UNITED STATES PATENT AND TRADEMARK OFFICE

10/570,803

| Office Action Summary | Application No. 10/570,803 | Applicant(s) YOON ET AL. | |

DETAILED ACTION

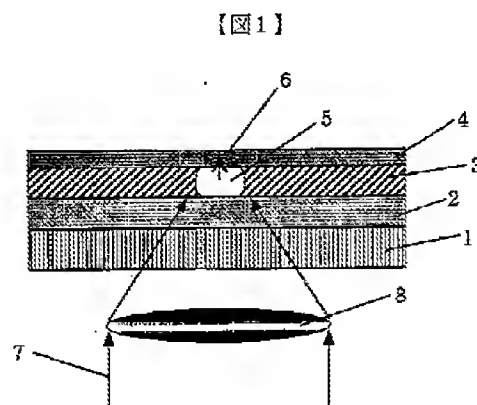
With regard to claim 1, Kuwabara et al. disclose a master optical disc [0002], which reads on applicants' recorded master, of the structure in Figure 1.

The device is comprised of a substrate 1, which reads on applicants' master substrate, an optical absorption thermal-conversion layer 3, which reads on applicants' heat absorption layer, a substrate protective layer 2, which reads on applicants' dielectric layer on at least one of top and bottom surfaces of the heat absorption layer, and a

feeling-of-heat reactive material layer 4 [0011], which reads on applicants' separation layer. The heating of the optical absorption thermal-conversion layer will transfer that heat to the feeling-of-heat reactive material layer as is implied by their names and as seen in the Figure (arrow showing direction of heat).

FIG. 7

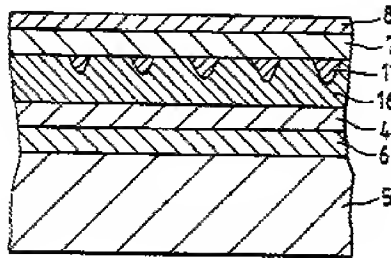
With regard to claim 1, Terao et al. disclose the device of Figure 7.

The optical medium of their invention may be considered a recorded master because the information contained within the recording layer may be reproduced and reused in the manufacture of an information storage medium (i.e. mp3 files). The device is comprised of a master substrate **8**, a heat absorption layer **16**, which is on the master substrate, and a separation layer **5** (col. 8, line 64 to col. 9, line 10 and col. 13, lines 17-36). The layer **16** has recorded data on the bumps or dents of the layer **16**, providing discrete data points.

With regard to claims 6 and 7, there may be top and bottom protection layers **7** and **4**, respectively, which are comprised of the a ZnS-SiO₂ dielectric mixture (col. 9, lines 2-5 and col. 13, lines 17-36).
